Response to
Dated
12/16/25

ENGINE IDLE & FUEL VAPOR IN CESSNA 172R / 172S

A Historical Compilation of Service Publications

January 12, 2026

Figure 1. Fuel Flow Divider (Sheet 1)

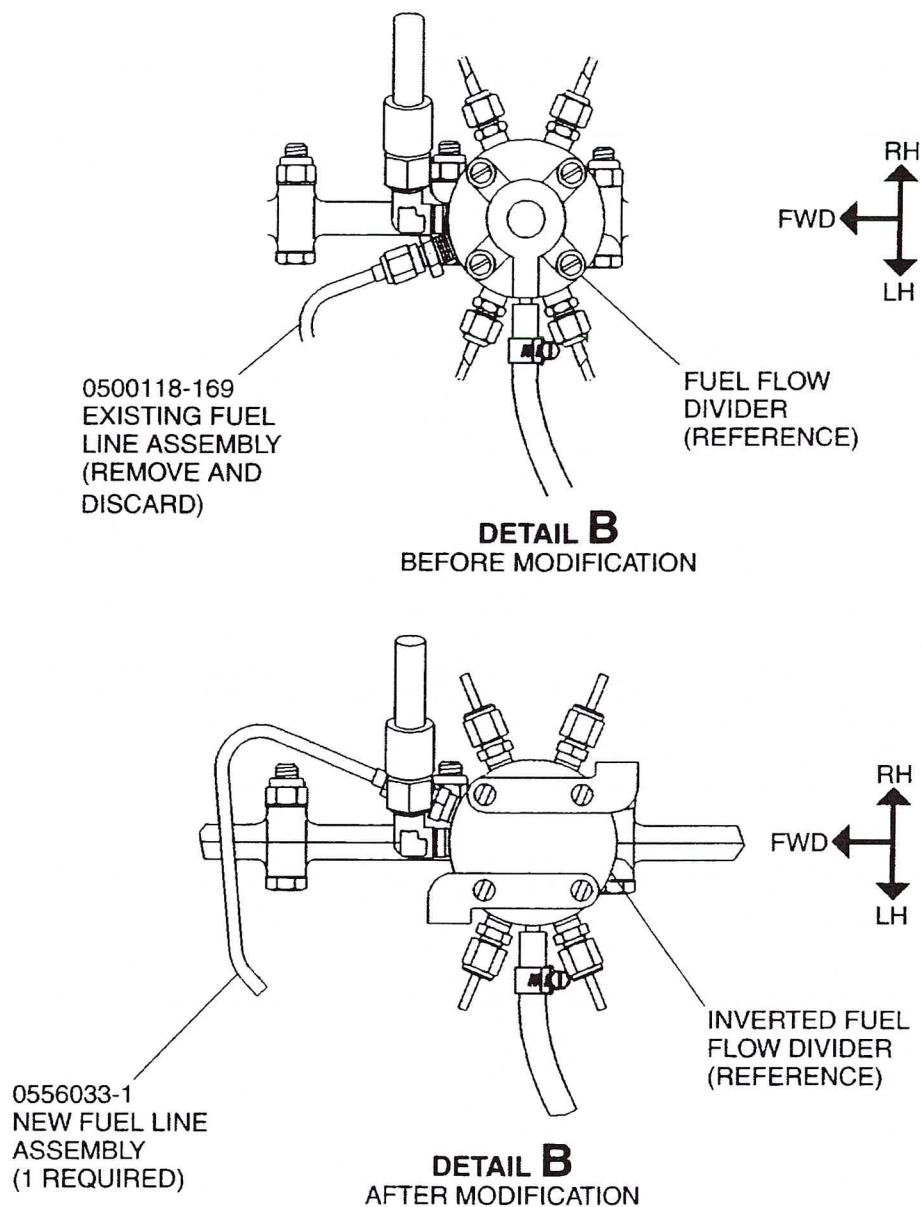
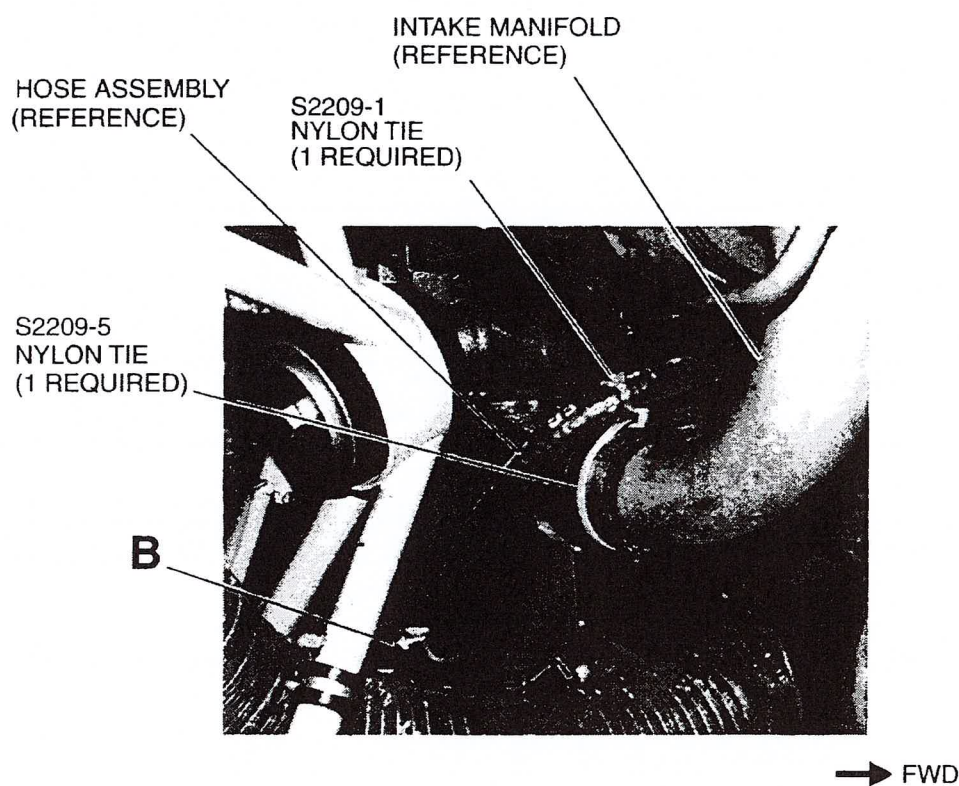
To aid in reducing possible fuel vapor during ground operations, the engine fuel flow divider installation may be modified by inverting the flow divider.

1. Electrically ground the airplane and turn all switches to the "OFF" position.
2. Remove upper and lower engine cowl. (Refer to the Model 172 Series 1996 And On Maintenance Manual, Chapter 71, Cowling - Maintenance Practices.)
3. Disconnect electrical power from the airplane by disconnecting the battery and external power. Attach maintenance warning tags to the battery and external power receptacle stating: **DO NOT CONNECT ELECTRICAL POWER - MAINTENANCE IN PROGRESS.**
4. (Refer to Figure 1, Sheet 1 and Sheet 2.) Modify the engine fuel flow divider as directed by Textron/Lycoming Service Instruction No.1502 (or latest revision).

Figure 2. Fuel Flow Divider Hose Routing (Sheet 1)

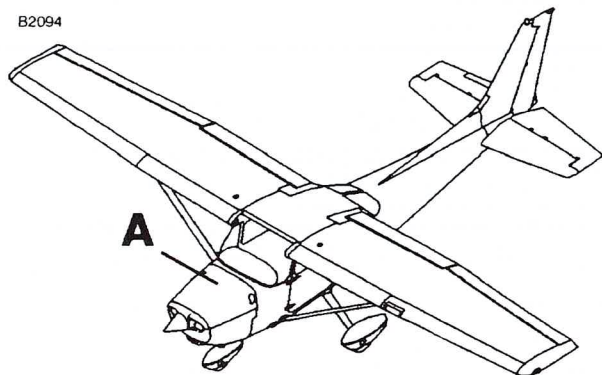
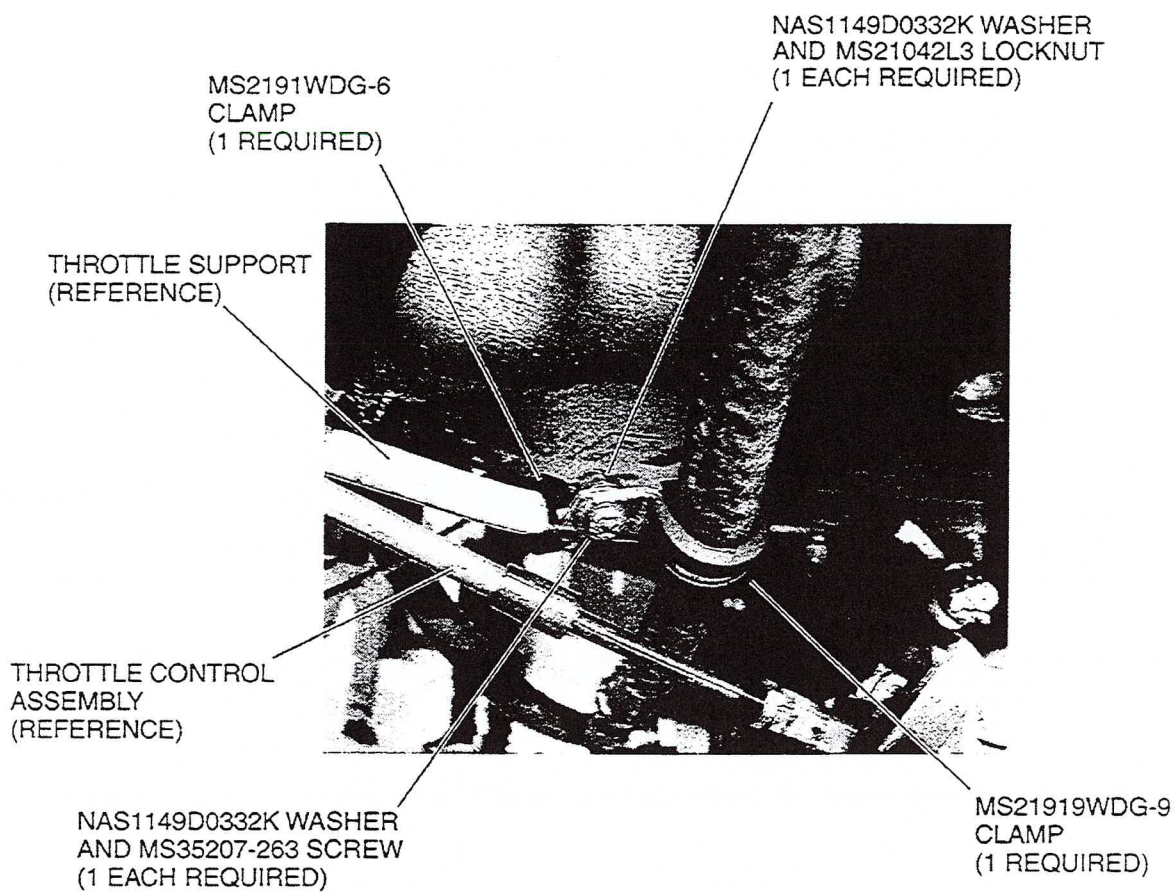
- A. (Refer to Figure 2, Sheet 1 and Sheet 2.) Re-position hose assembly over intake manifold and up to fuel flow divider.
 - B. Secure line with one (1) MS21919WDG6 Clamp, one (1) MS2191WDG9 Clamp, two (2) NAS1149D0332K Washers, one (1) MS35207-263 Screw and one (1) MS21042L3 Locknut to the throttle support.

NOTE: Ensure hose assembly is clear of the throttle control assembly when securing line.
 - C. (Refer to Figure 2, Sheet 1.) Secure hose assembly to intake manifold with one (1) each S2209-5 and S2209-1 Nylon Tie.
5. Check and adjust the idle speed and mixture control as required. (Refer to the Model 172 Series 1996 And On Maintenance Manual, Chapter 73, Idle and Mixture Adjustment.)
 6. Reinstall engine cowl. (Refer to the Model 172 Series 1996 And On Maintenance Manual, Chapter 71, Cowling - Maintenance Practices.)
 7. Remove maintenance warning tags and reconnect the airplane battery.

Figure 1.

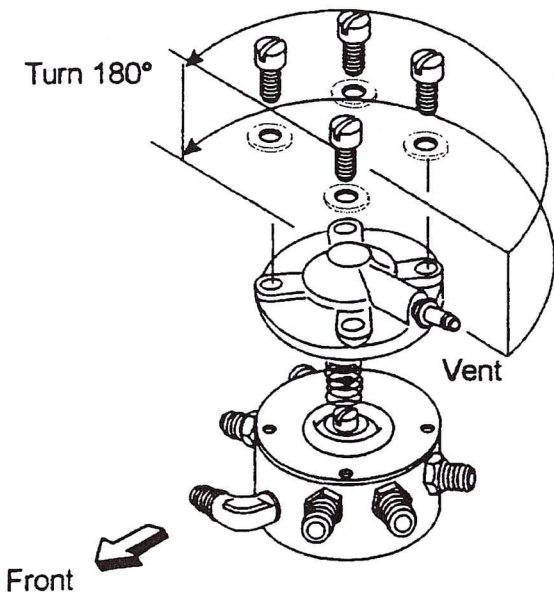
- a. Remove the lockwire, screws and washers from the top of the flow divider assembly. (Figure 1.)
- b. With the cap vent pointing left, slightly lift the manifold cap, making sure that it is separated from the diaphragm. Then carefully rotate it until cap vent points right. (180° from original position.) (Figure 1.) Be sure that the spring held in place by the cap is not dislodged.

Figure 2.

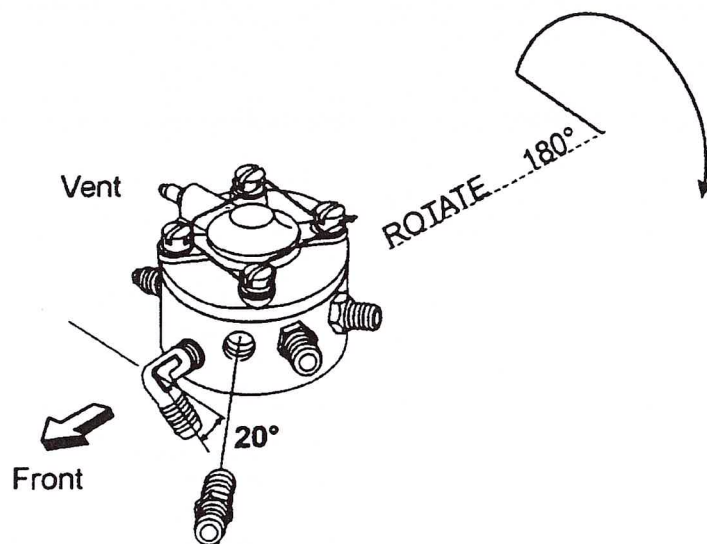
- d. To allow removal and installation of the 90° fuel inlet elbow, first remove the fuel gage fitting close to the elbow on the forward side of the flow divider. (Figure 2.)

- e. Holding the flow divider with the manifold cap up, remove the 90° elbow P/N MS20822-4 and install the new 90° elbow with the elbow positioned below the gage fitting port pointed left and tilted approximately 20° below horizontal. Reinstall gage nipple. The angle allows clearance for hose connections. Before reinstalling the fittings, apply Loctite Hydraulic Sealant or an equivalent fuel soluble sealant sparingly. Do not apply sealant to the first two lead threads. (Figure 2.)

Figure 1. Warm Air Duct Modification (Sheet 1)

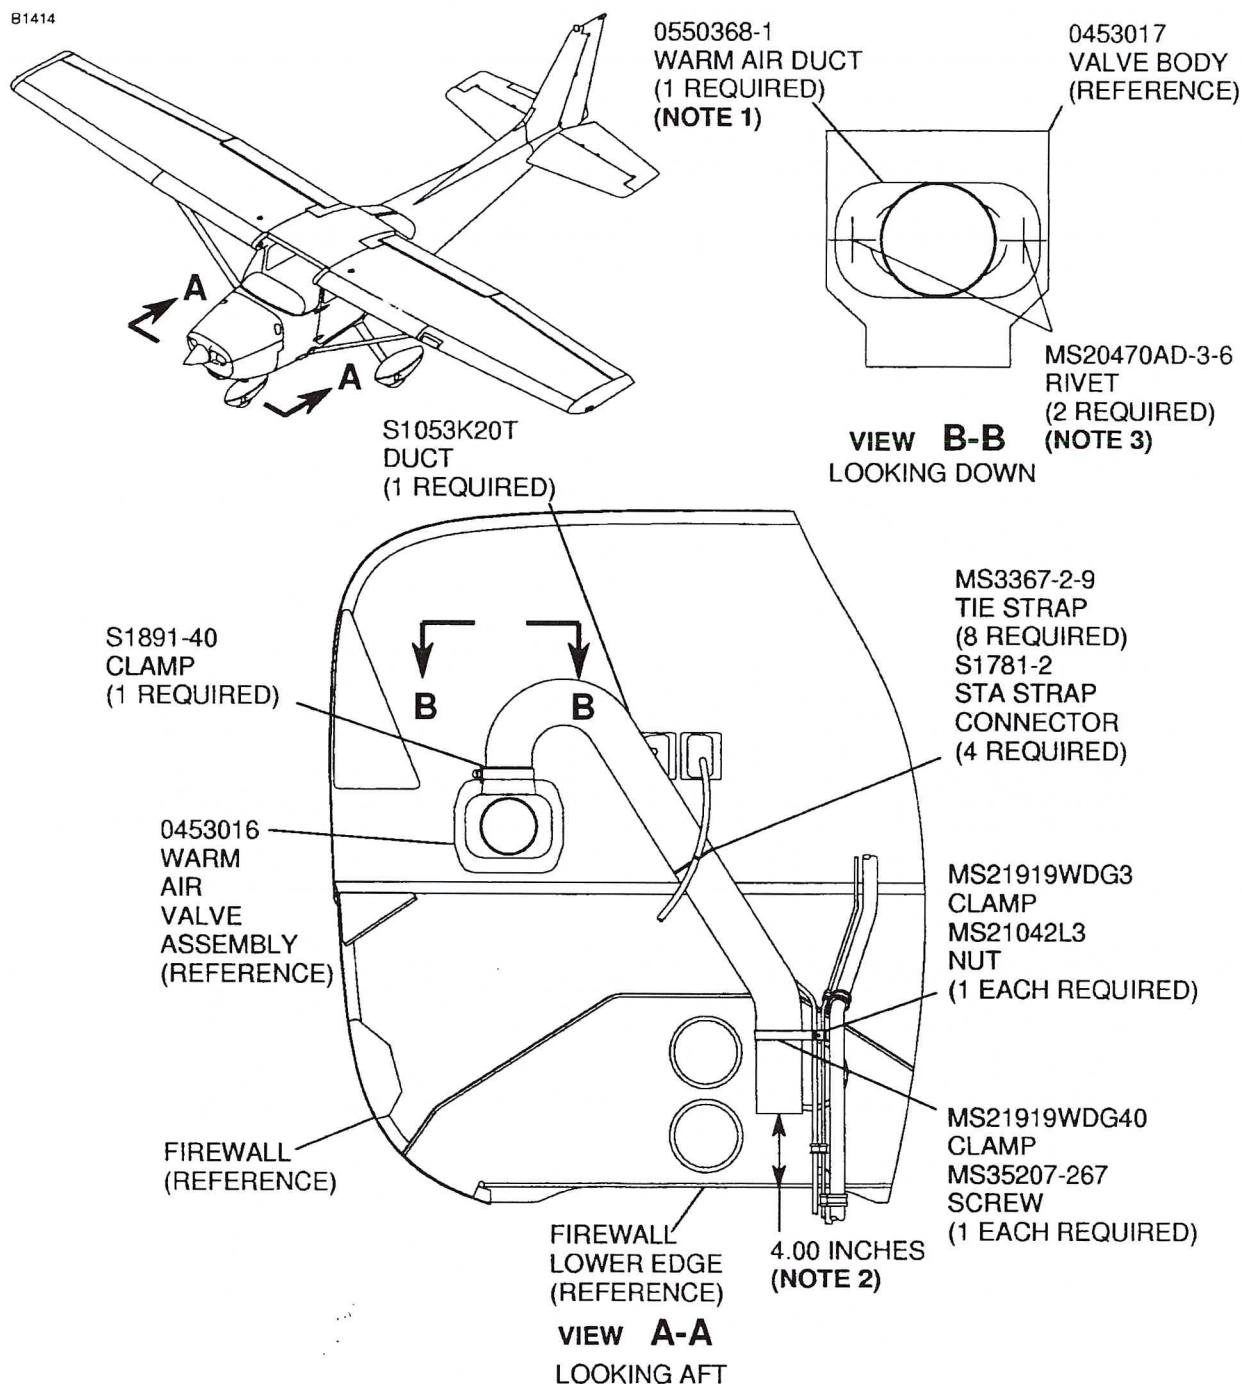
7. (Refer to Figure 1.) Attach the 0550368-1 Warm Air Duct to the 0453017 Valve Body.
 - A. Bend the 0550368-1 Warm Air Duct flanges to match the upper contour of the 0453017 Valve Body and then align the warm air duct with the upper hole in the valve body.

Figure 1. Fuel Return System Installation (Sheet 1)

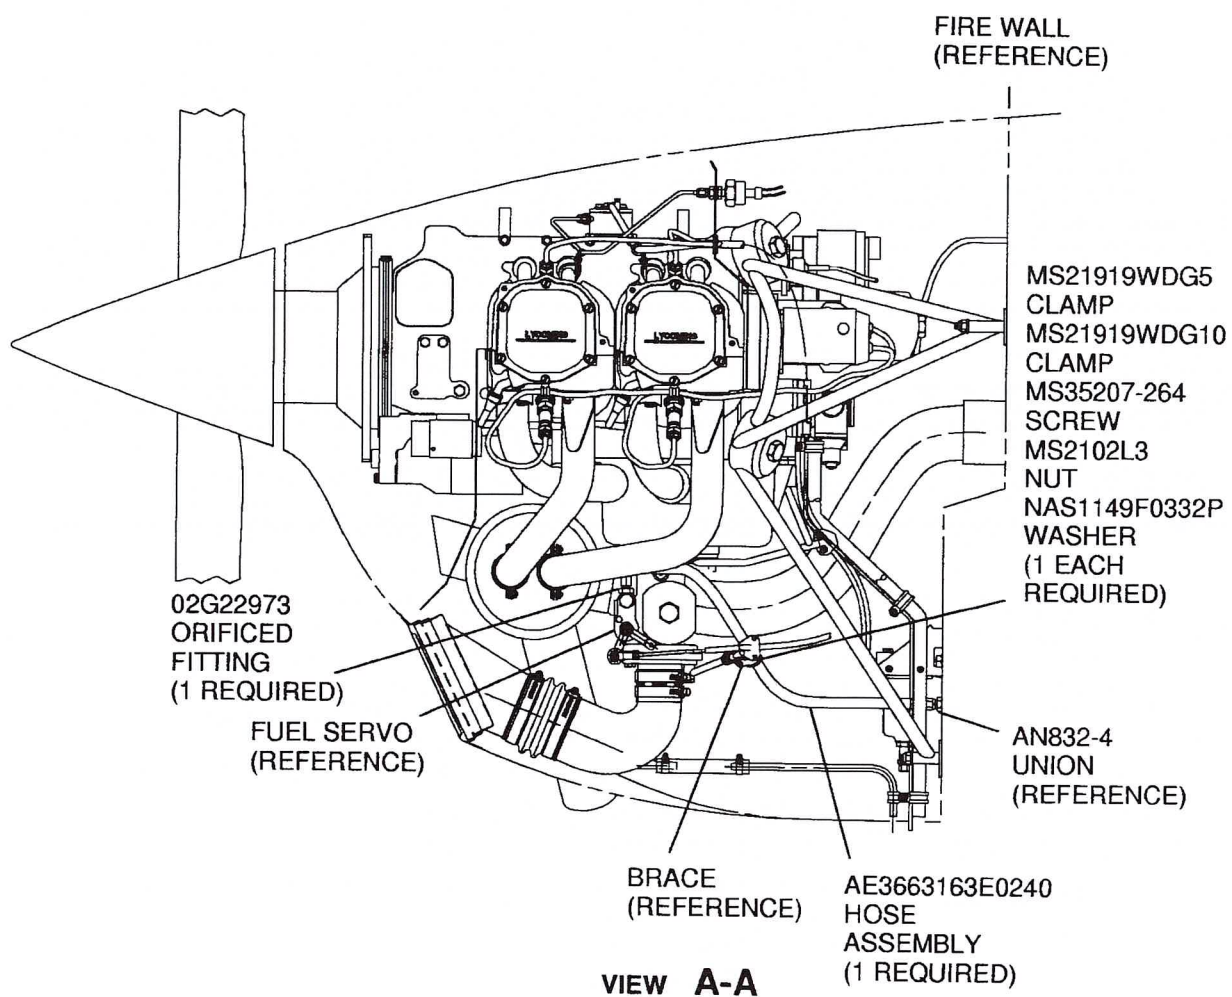
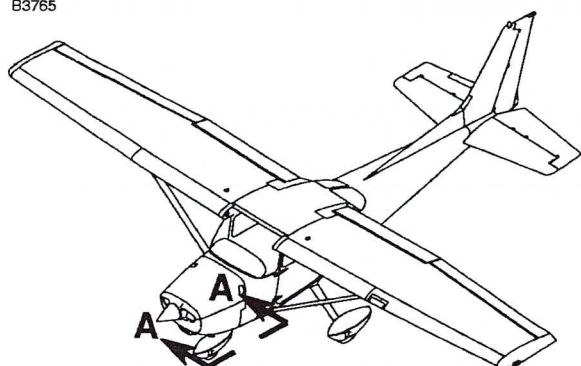
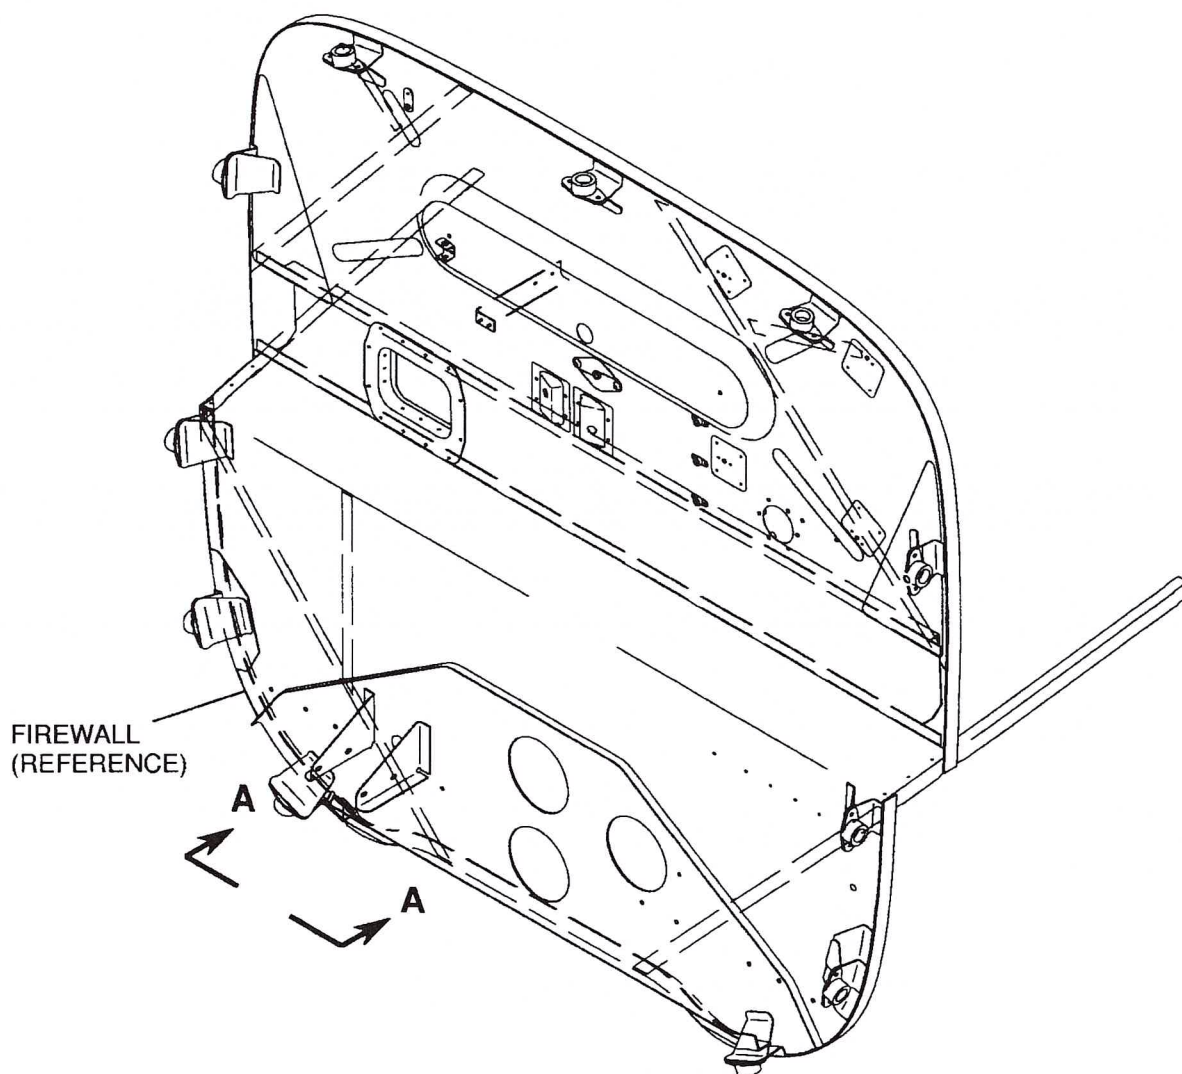
5. Defuel the airplane. (Refer to the Model 172 Series 1996 and On Maintenance Manual, Fuel - Servicing.)
6. Remove the copilot seat and carpet. (Refer to Chapter 25, Front Seats and Rails - Maintenance Practices and Chapter 25, Interior Upholstery - Maintenance Practices.)
 - A. Remove the copilot side 0515075-40 Panel to get to the fuel reservoir assembly.
 - B. Remove the copilot side 0513512-9 Forward Floorboard and the access panel behind the rudder pedals to get to the fuel reservoir.
7. (Refer to Figure 1.) Remove the safety wire and plug in the forward top side of the fuel servo and install a 02G22973 Orificed Fitting with a MS29512-04 O-Ring.

Figure 2. Fuel Return Firewall Hole Installation (Sheet 1)

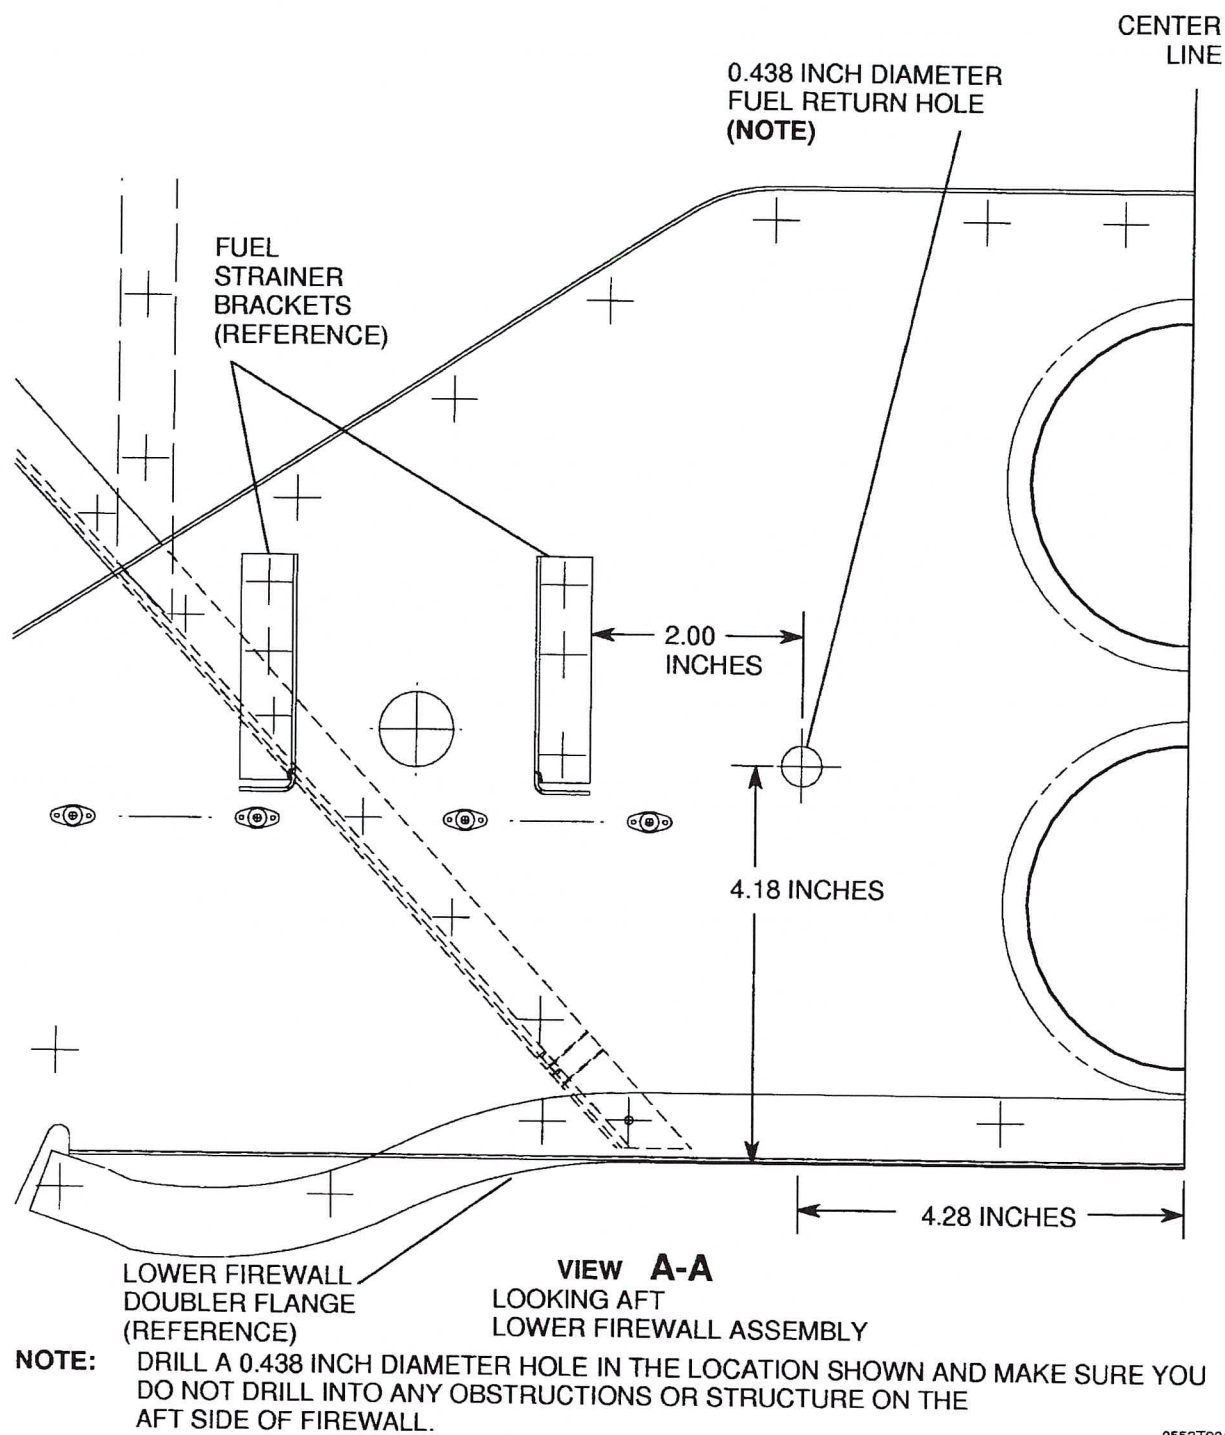
8. (Refer to Figure 2, Sheet 1 and 2.) Drill 0.438 inch diameter fuel return hole in the firewall as shown.
9. (Refer to Figure 3, Sheet 2.) Install a AN832-4 Union, NAS1149F0932P Washer, and AN924-4 Nut in the firewall fuel return hole as shown.
10. (Refer to Figure 1, View A-A.) Install a AE3663163E0240 Hose Assembly between the fuel servo orificed fitting and the firewall AN832-4 Union.
 - A. Remove the protective cap on the 02G22973 Orificed Fitting installed in Step 7 and install the AE3663163E0240 Hose Assembly nut to the orificed fitting. Leave the nut loose until the hose is positioned and clamped to the brace as shown.
